SITE PLAN REVIEW REPORT – Town of Guilderland Planning Board

March 8, 2023

Laviano Mixed Use Commercial Building

1859-1871 Western Avenue

Neighborhood Aerial Photo

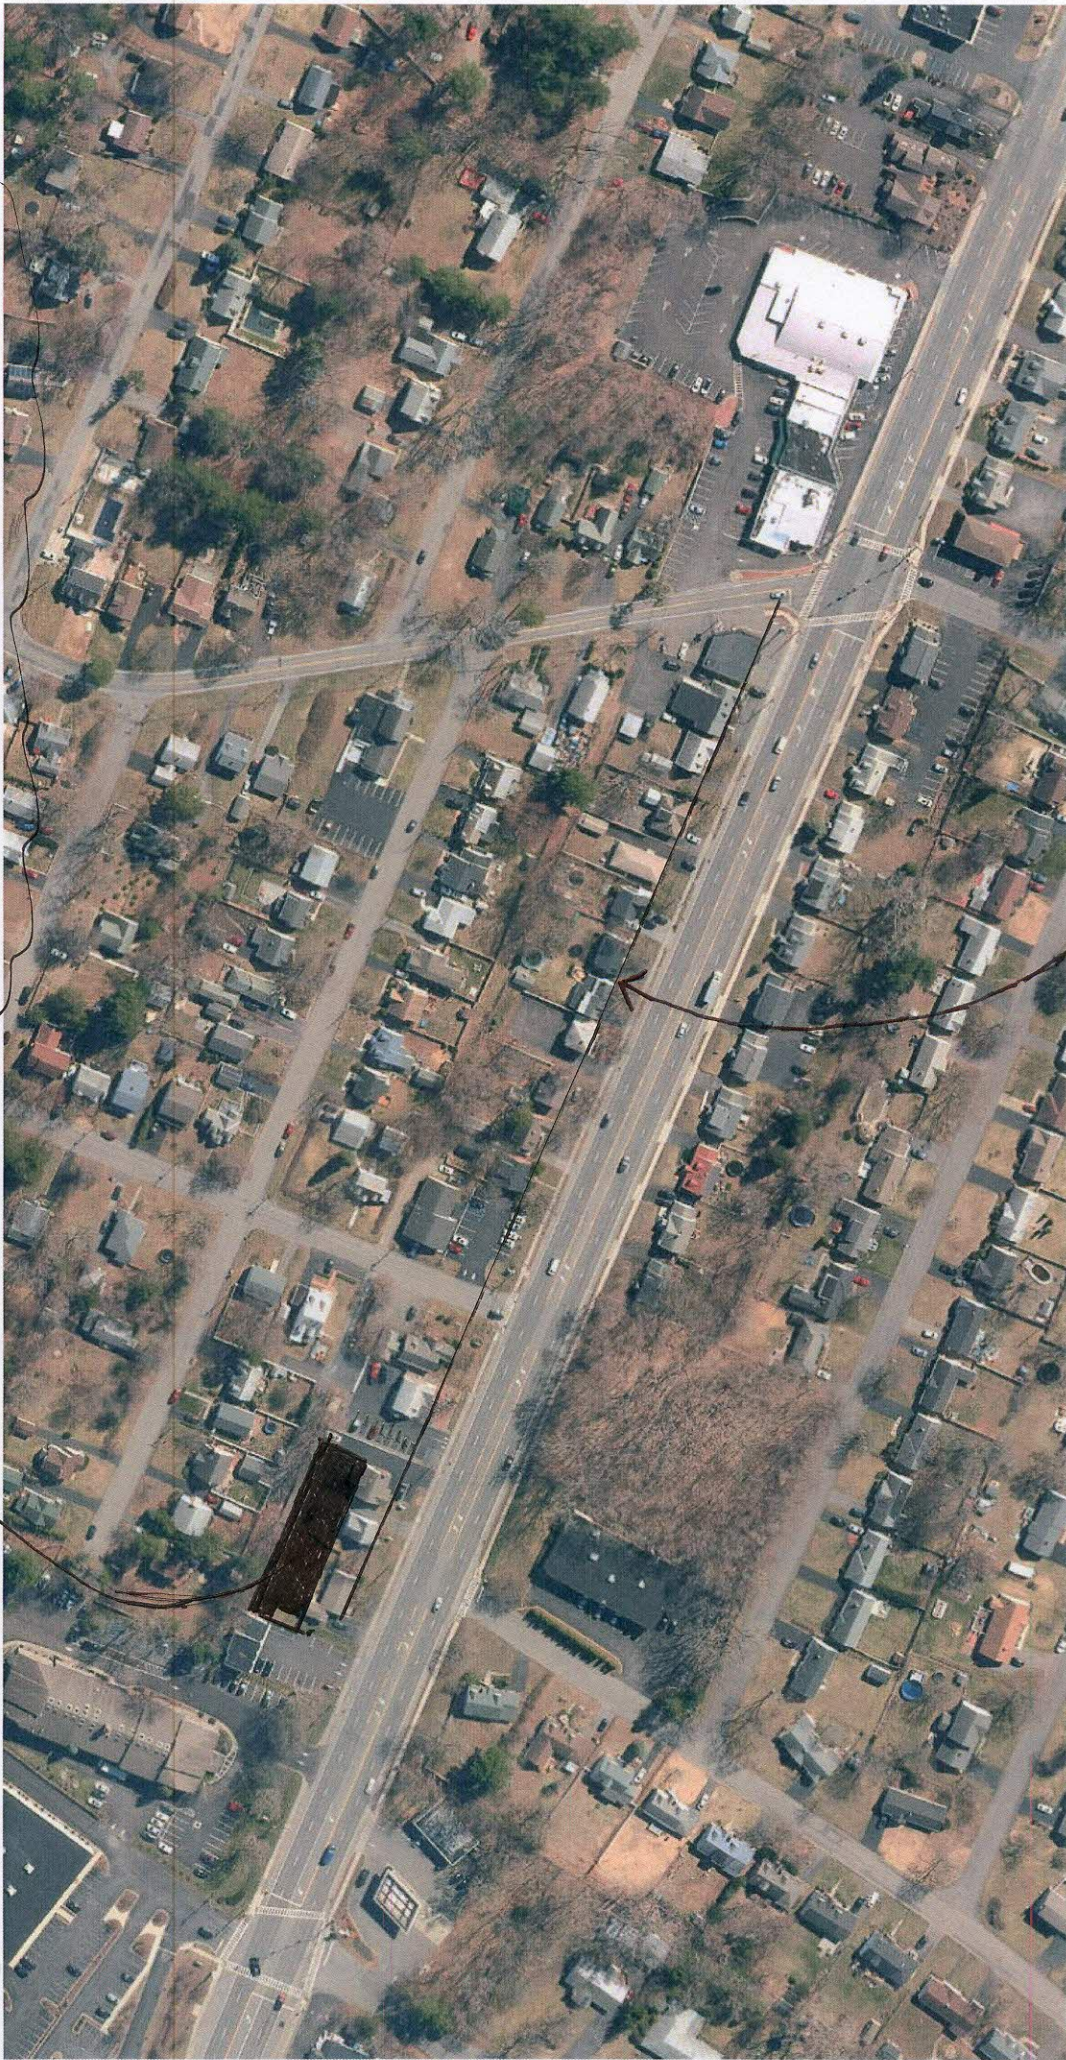
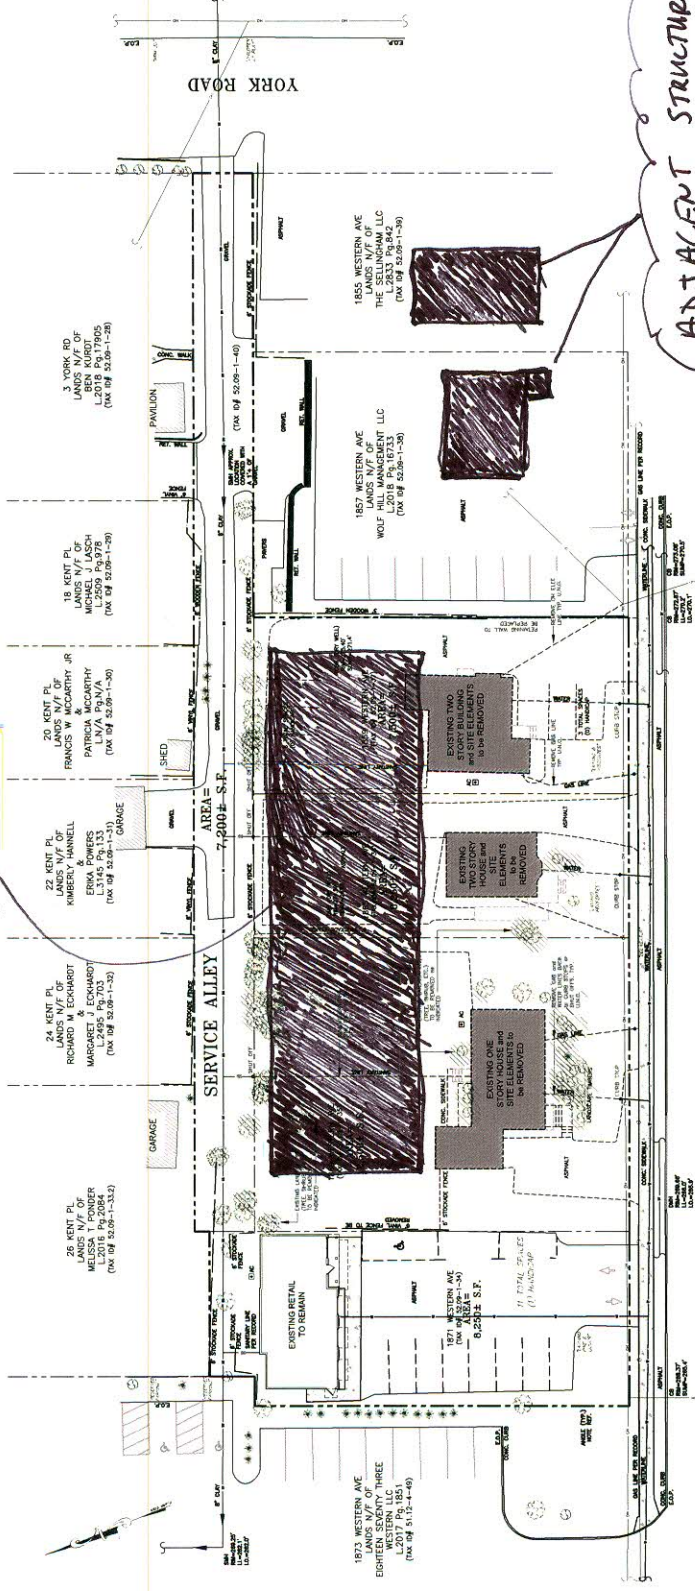
PROPOSED STRUCTURE

INAPPROPRIATE SETBACK - OUT OF CHARACTER WITH BUILDINGS ON THE STREET FRONTAGE

MASS OF BUILDING NOT AT COMPATIBLE SCALE

ESTABLISHED BUILDING WALL

PROPOSED BUILDING

ADJACENT STRUCTURES
 IN BNRP ZONE
